SUBJECT: Forwards response to NRC 790907 ltr requesting addl info re conceptual safety grade reactor trip design. Discusses conformance w/SRP & IEEE-279-171 design requirements. Oversized drawings encl.

Re: Oconee Nuclear Station
Docket Nos 50-269, -270, -287

DUKE POWER COMPANY
OCONEE NUCLEAR STATION
RESPONSE TO REQUEST FOR ADDITIONAL INFORMATION
SAFETY GRADE ANTICIPATORY REACTOR TRIP

PRESSURE VS TIME TO TRIP FOR
A LOSS OF MAIN FEEDWATER
FROM 100% POWER

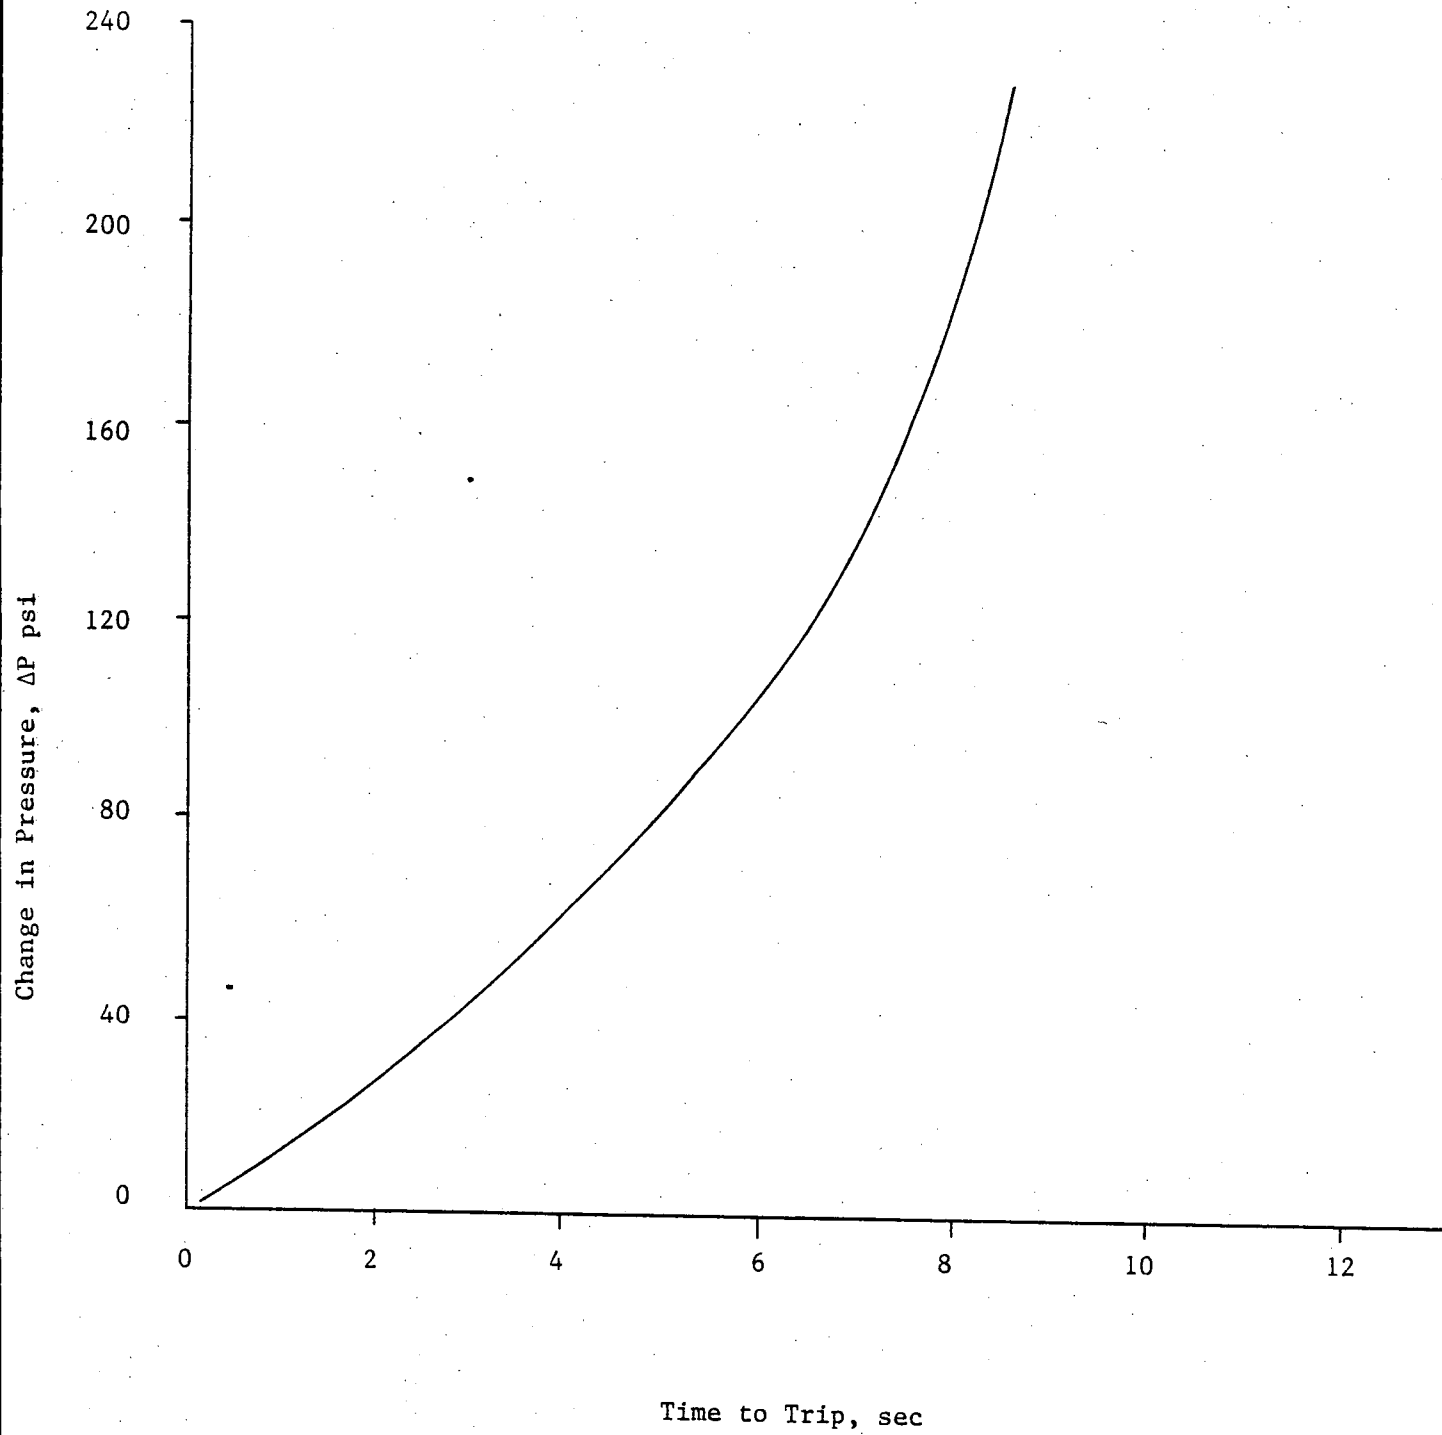
Question 9. The safety evaluations for the anticipatory trips are either missing or are incomplete. Submit supporting analysis to justify the proposed trip signals by addressing the following items:

- a. Provide an analysis that quantifies the improvement in the time-to-reactor-trip for both the turbine trip and and loss of main feedwater signals;
- b. Address the need to bypass these trips at 20% power versus bypass at a lower power (approximately 10%);
- c. Discuss the adequacy of the proposed trip signals for loss of main feedwater for a variety of failure scenarios (such as feedwater valve closures), i.e., see the Oconee 1 transients of June 11, 1979; and
- d. Provide an evaluation of why a reactor trip on low steam generator level is not a viable anticipatory trip signal when the other signals are bypassed, i.e., see the Crystal River 3 transient of August 2, 1979.

- a. The primary purpose of anticipatory reactor trips (ARTs) is to reduce the challenges to the PORV for loss of secondary heat sink conditions. For a reactor high pressure trip setpoint of 2300 psig, it was shown in References 1 and 2 that the PORV would not lift with a setpoint of >2400 psig. The margin to the PORV setpoint can be increased, however, by use of ARTs. Figure 9a-1 shows the pressure increase from nominal operating pressure as a function of time to trip for the loss of main feedwater event. From this figure, it can be seen that an ART that detects and trips the plant at 4 seconds results in a peak pressure increase of 60 psi; whereas the high RC pressure trip which would occur at 8 seconds results in a peak pressure increase of 184 psi. The anticipatory trip signals which have been selected will initiate a reactor trip in less than one second. As seen on Figure 9a-1, a one second time to trip results in a 12 psi pressure increase, compared to a 184 psi pressure increase for the high pressure trip at 8 seconds.

The analyses presented above are for a loss of main feedwater event which produces higher peak pressures than turbine trips produce. The time to reactor trip after a turbine trip from full power is, however, approximately the same as that for a loss of main feedwater.

Figure 1

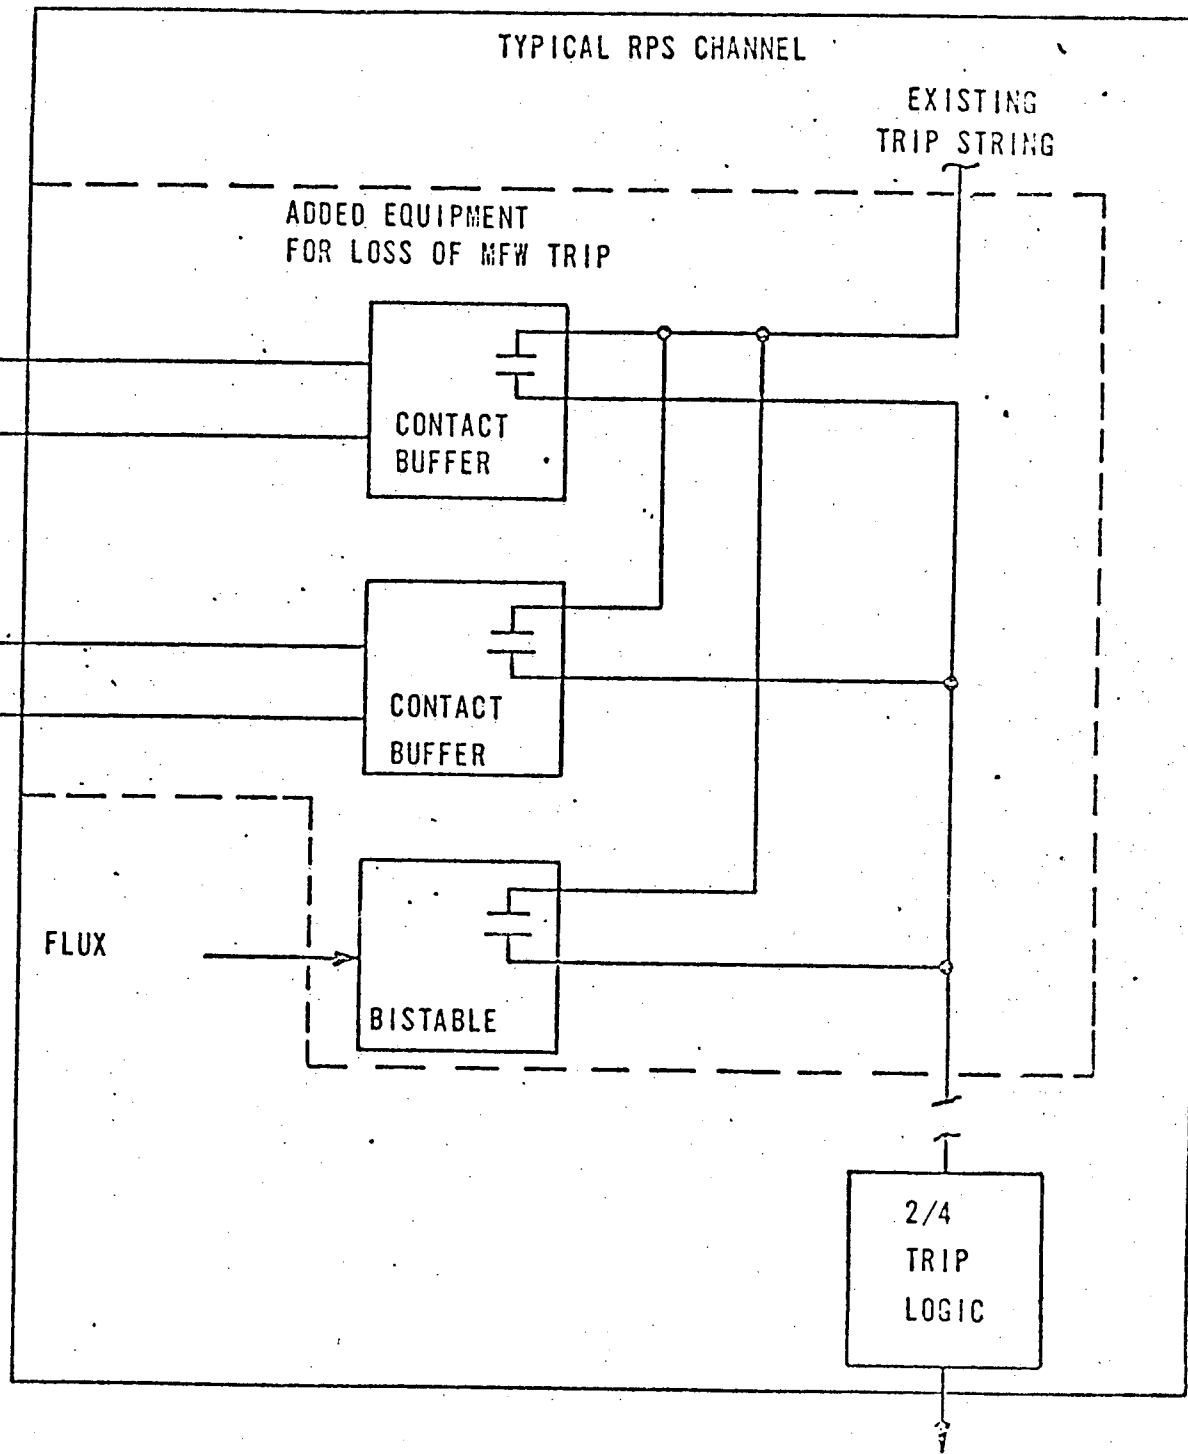
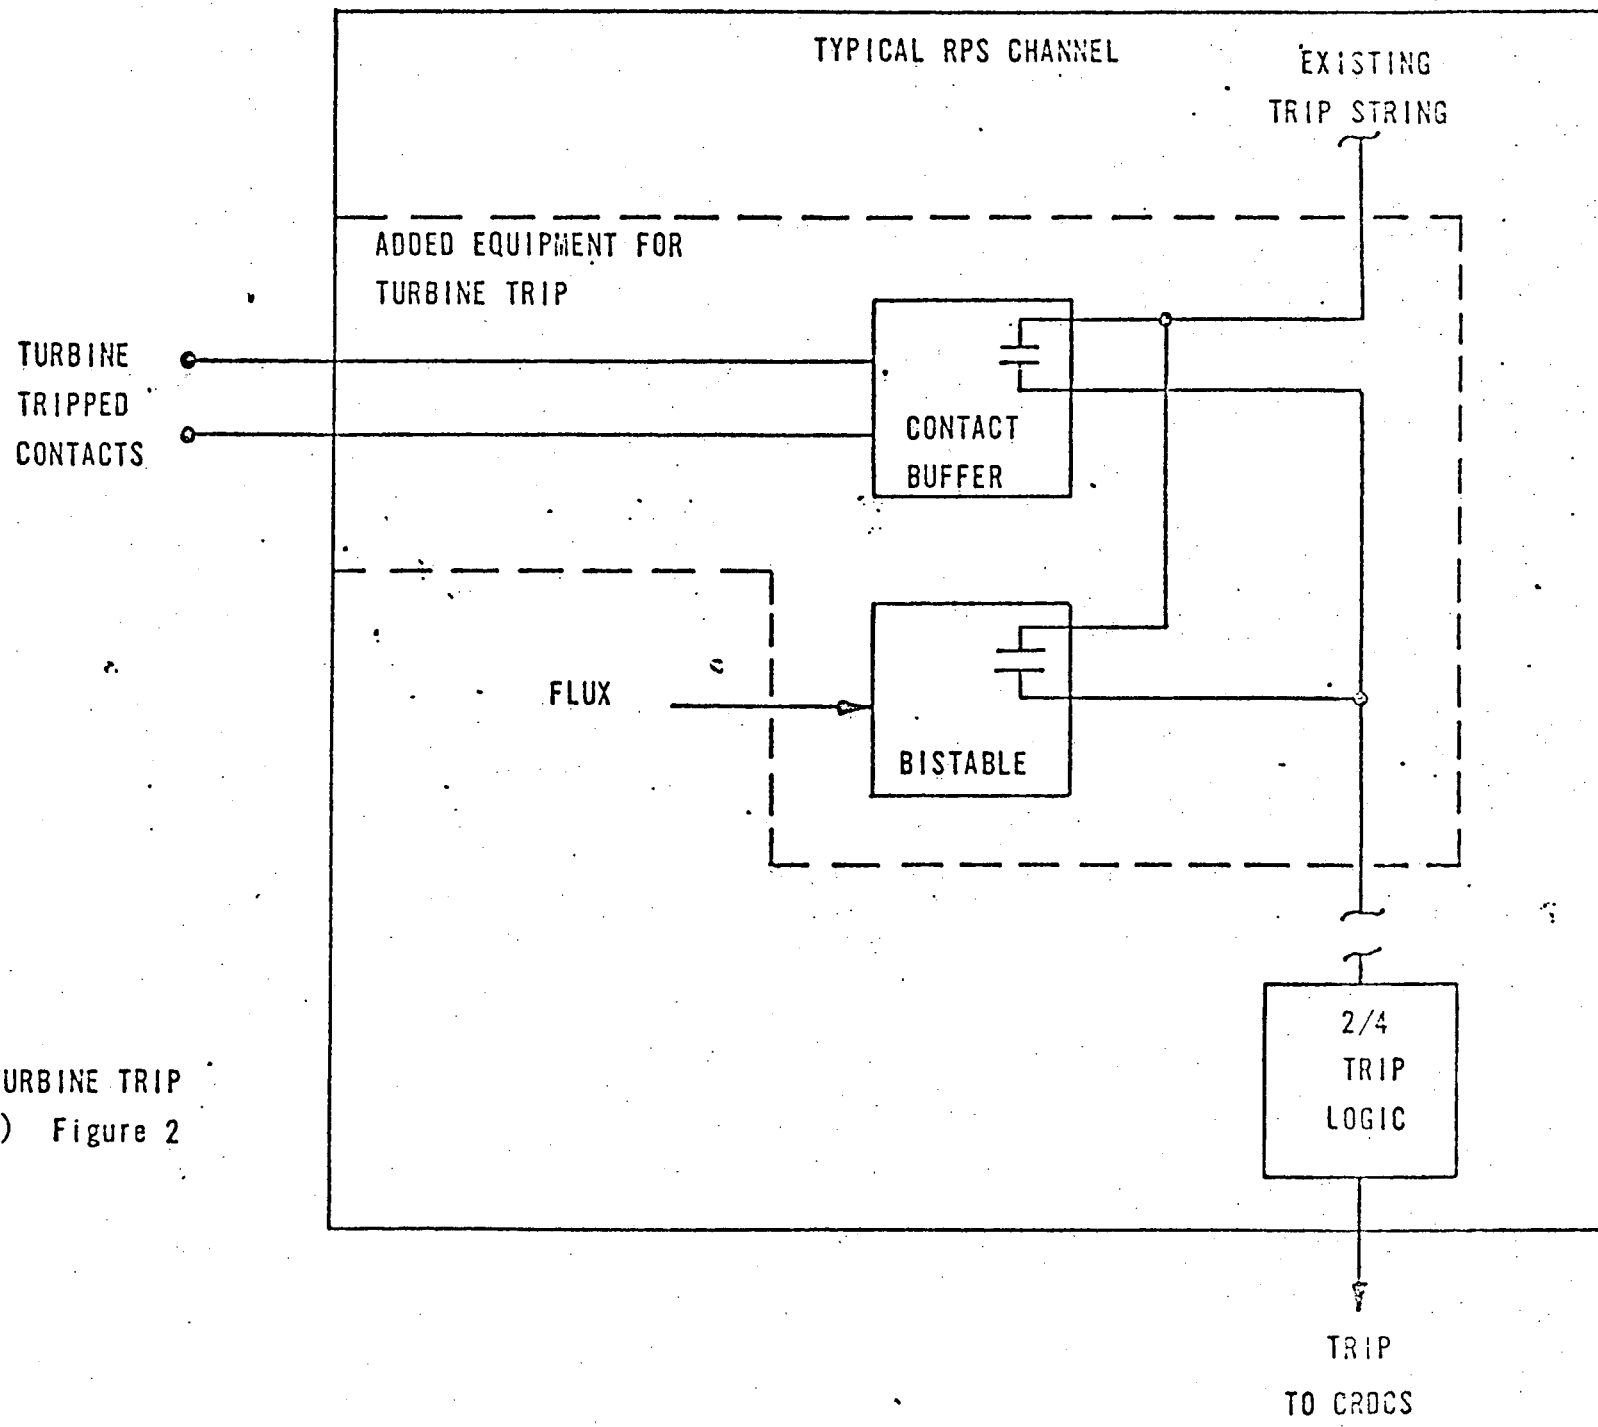
Question 3. Provide a description of any changes to and/or interfaces with the existing protection system. Include diagrams (block, location, functional and/or elementary wiring), as necessary, to clearly depict the changes and/or interfaces. In addition, provide an analysis which demonstrates that these changes and/or interfaces will not degrade the existing protection system.

The anticipatory trip equipment will be added to the RPS cabinets and will interface as new trips in the present bistable trip string. Figures 1 and 2 of the Attachment I show the functional interface of the added equipment with the RPS. Drawings 51079DGB-1 and 51079MLG-1 of the attachment describe the inputs, outputs, and logic of the new trip functions. The added modules will consist of contact buffers, bistables, and auxiliary relays, which have been tested and qualified for use in a safety system. Existing RPS power supplies, flux signals, interlock circuits, and indicators will be used as required by the added equipment. The requirements for the RPS, e.g., cooling, power, seismic, environmental, will be the same for the system with anticipatory trips as the requirements prior to addition of the new trips.

Loss of Main Feedwater Trip - Control oil pressure switches or Feedwater header discharge pressure switches for each feedwater pump will input an open indication to the RPS on feedwater pump trip. Contact buffers in the RPS will sense the contact inputs and initiate an RPS trip when both pumps have tripped. This trip will be bypassed below a predetermined flux level, typically 20% FP. Reference Figure 1.

Figure 1 is a simplified drawing of the main feedwater pump trip.
